SUBJECT: ISSUANCE OF AMENDMENT NO. 73 TO FACILITY OPERATING LICENSE  
NO. NPF-29 - GRAND GULF NUCLEAR STATION, UNIT 1, REGARDING FUEL  
CYCLE 5 RELAOD (TAC NO. 76992)

GRAND GULF NUCLEAR STATION, UNIT 1

AMENDMENT TO FACILITY OPERATING LICENSE

Amendment No. 73  
License No. NPF-29

FIGURE 3.2.1-1 MAPLHGR vs AVERAGE PLANAR EXPOSURE FOR ANF FUEL

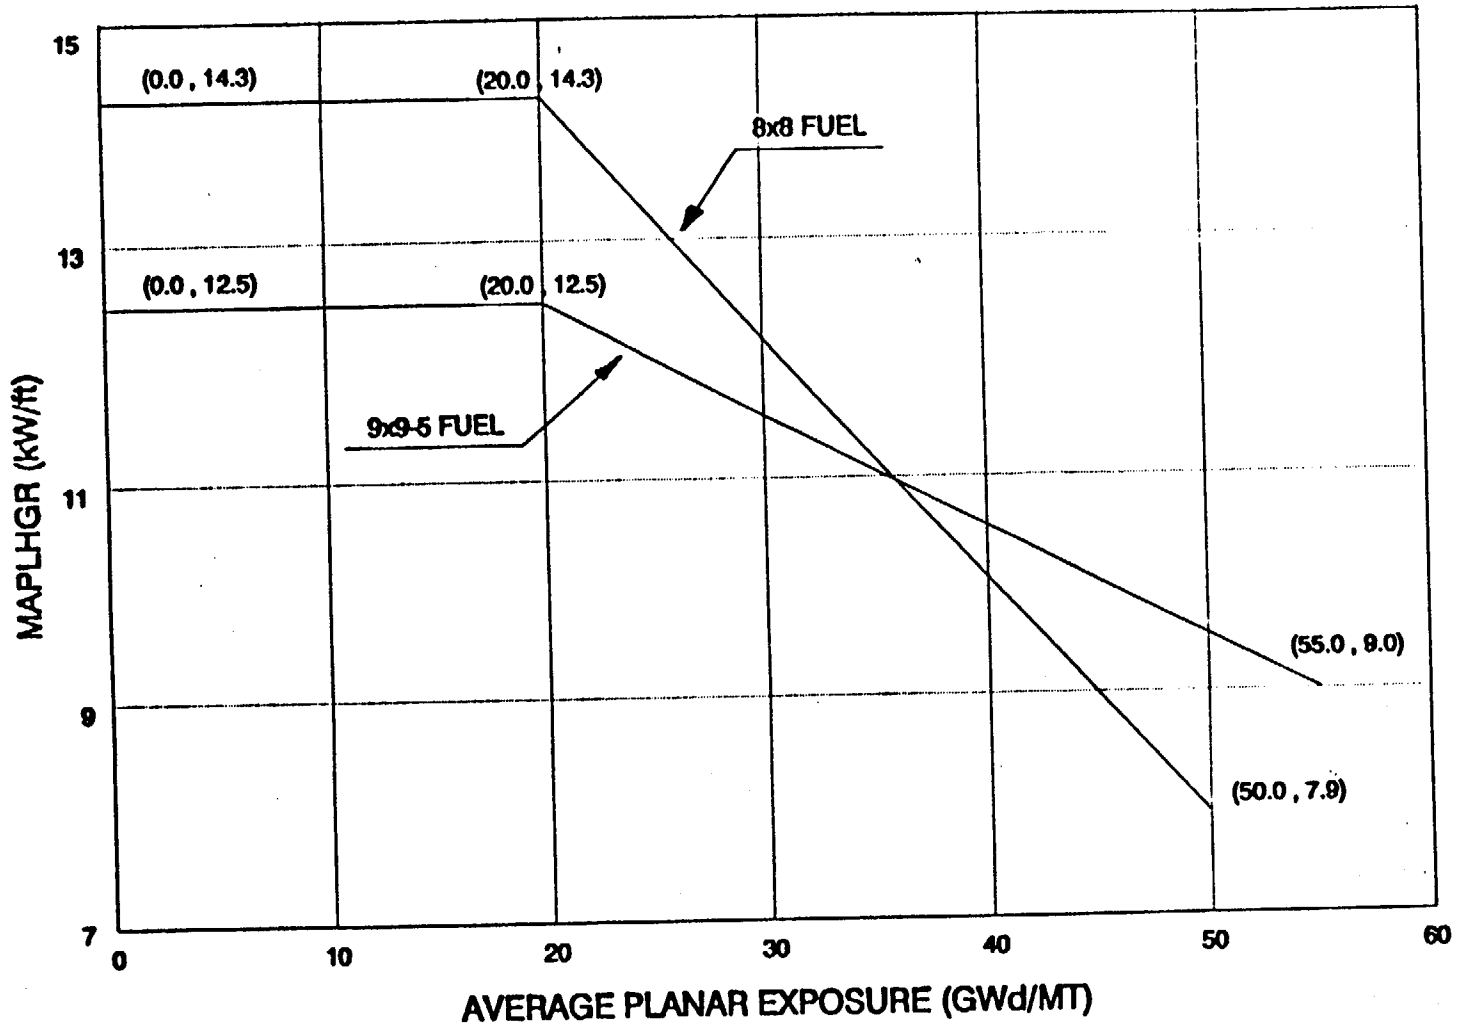
- (4) TS 3/4.2.1 -- The changes delete references to fuel type specific MAPLHGR curves, and delete references to MAPFAC curves. As previously discussed, the MAPFAC limits have been transferred to LHGR limits and the analysis of MAPLHGR limits for LOCA (only) have covered ANF 8x8 and AFN 9x9 fuel generically. These changes are acceptable. ANF has also determined that the SLO MAPLHGR multiplier is now 0.80. This change is also acceptable. Figure 3.2.1-1 is changed to show the new ANF 8x8 and 9x9 MAPLHGR values and Figures 3.2.1-1a through 3.2.1-1e, 3.2.1-2, and 3.2.1-3 are deleted because, as indicated above, the values are no longer used. This is acceptable.

3.2.1 During two loop operation, all AVERAGE PLANAR LINEAR HEAT GENERATION RATES (APLHGRs) for each type of fuel as a function of AVERAGE PLANAR EXPOSURE shall not exceed the limits shown in Figure 3.2.1-1.

During single loop operation, the APLHGR for each type of fuel as a function of AVERAGE PLANAR EXPOSURE shall not exceed the limit shown in Figure 3.2.1-1 multiplied by 0.8.

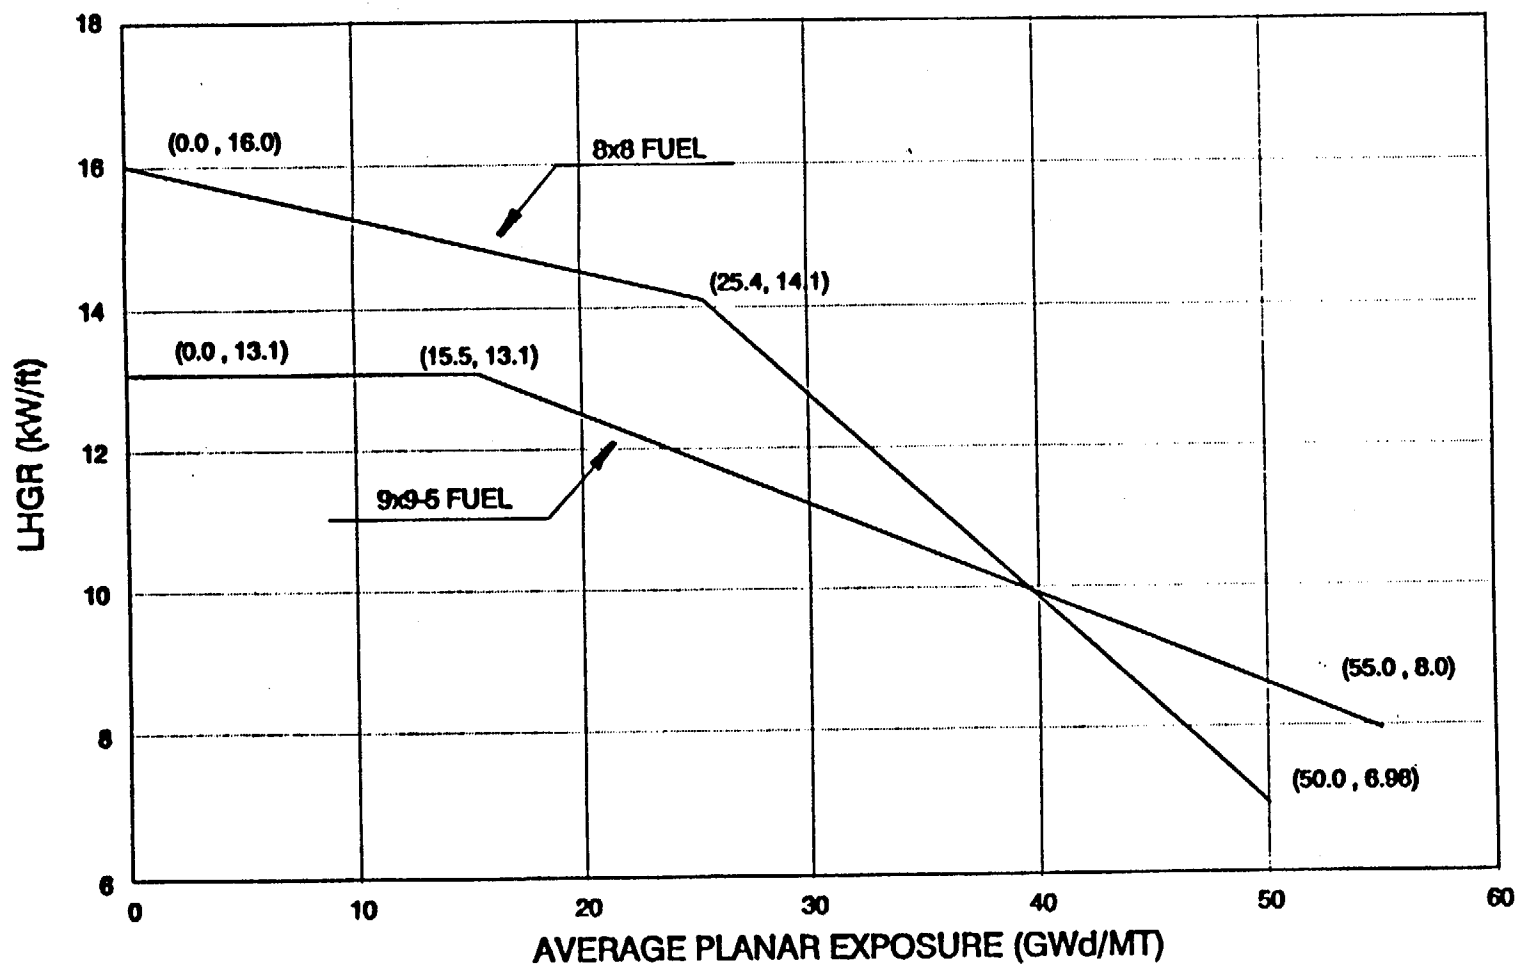
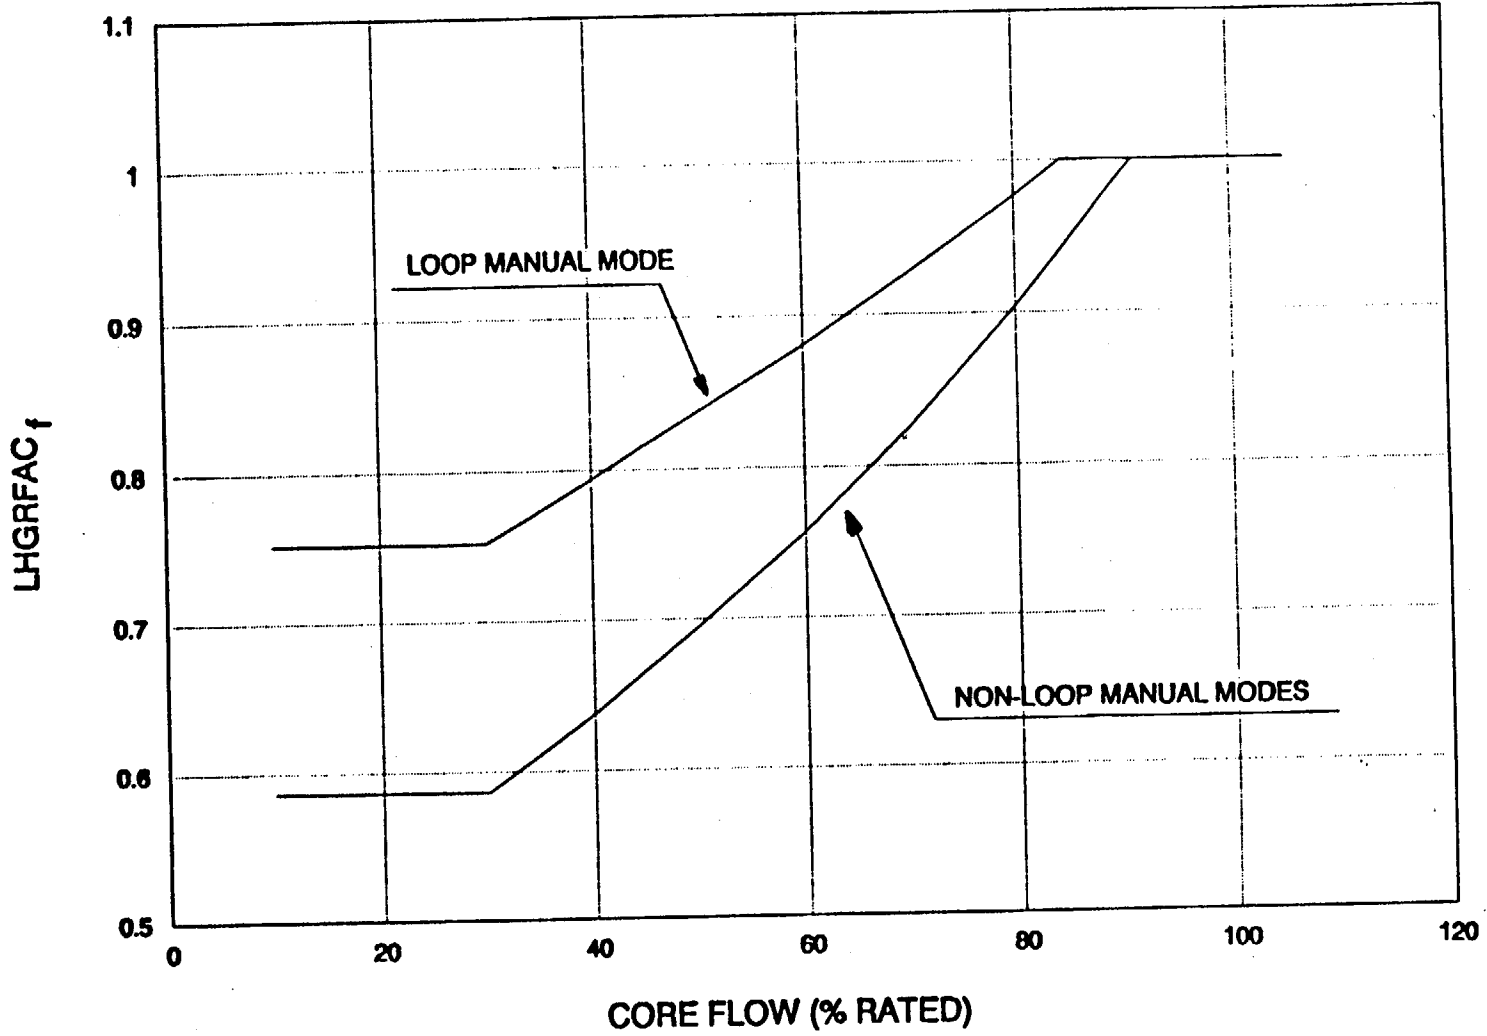
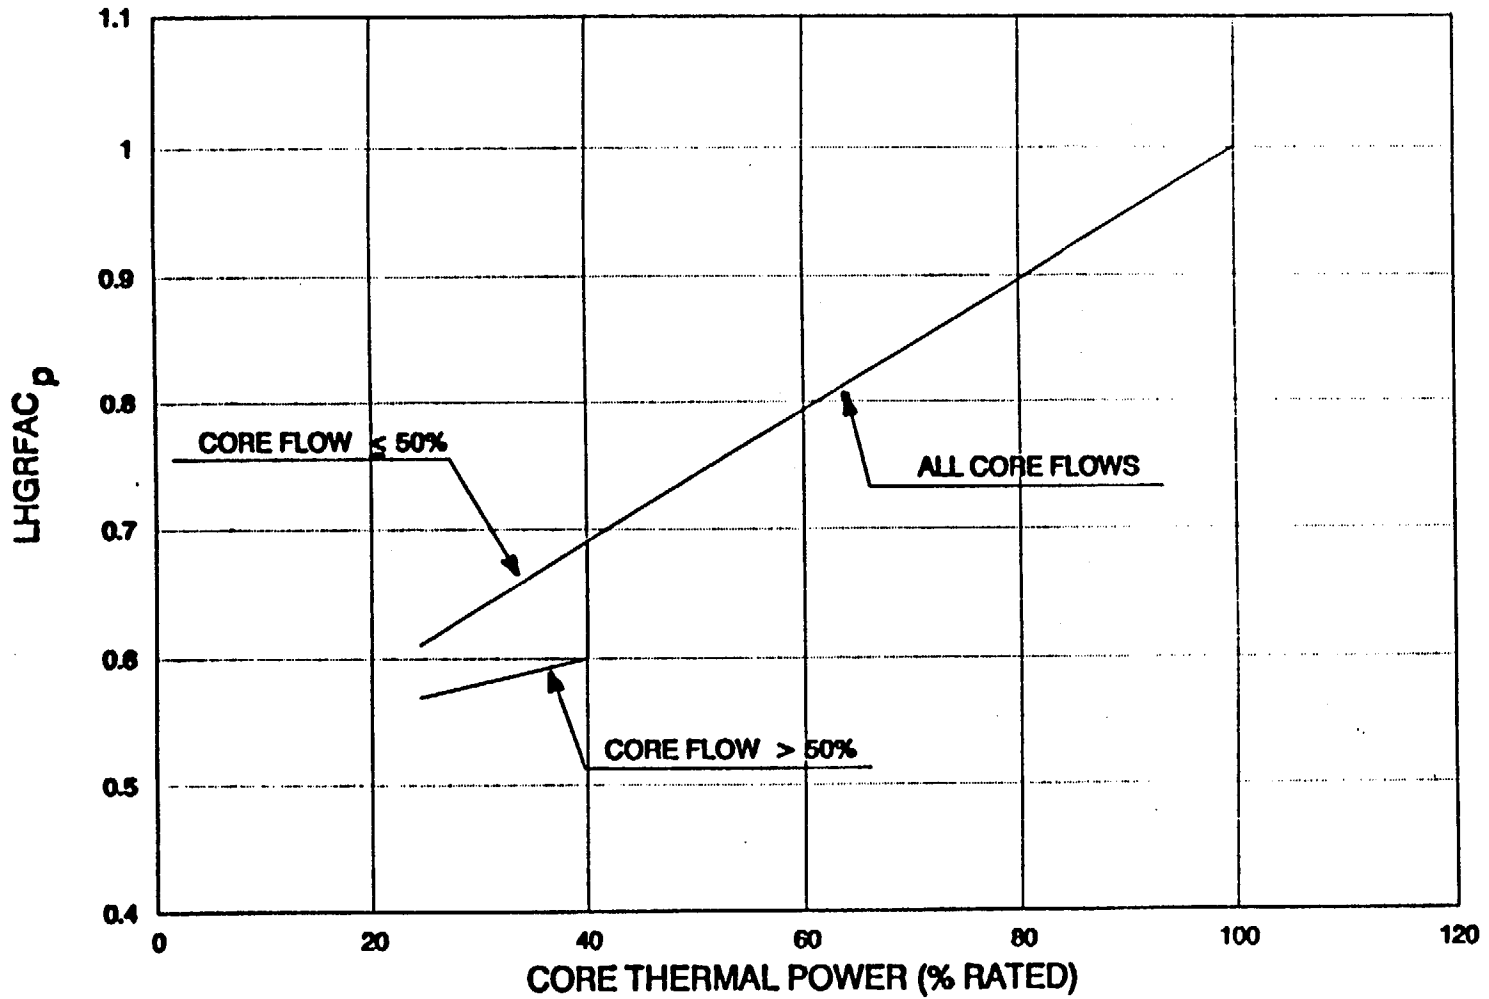
- (6) TS 3/4.2.4 -- The text is changed to reflect the addition of the LHGRFAC multipliers as has been previously discussed. Figures 3.2.4-1, 3.2.4-2, and 3.2.4-3 have been revised or added to reflect these changes and the extended ANF LHGR curve (also previously discussed). The changes are acceptable.

3.2.4 The LINEAR HEAT GENERATION RATE (LHGR) shall not exceed the limits shown in Figure 3.2.4-1 as multiplied by the smaller of either the flow-dependent LHGR factor (LHGRFAC<sub>f</sub>) of Figure 3.2.4-2, or the power-dependent LHGR factor (LHGRFAC<sub>p</sub>) of Figure 3.2.4-3.
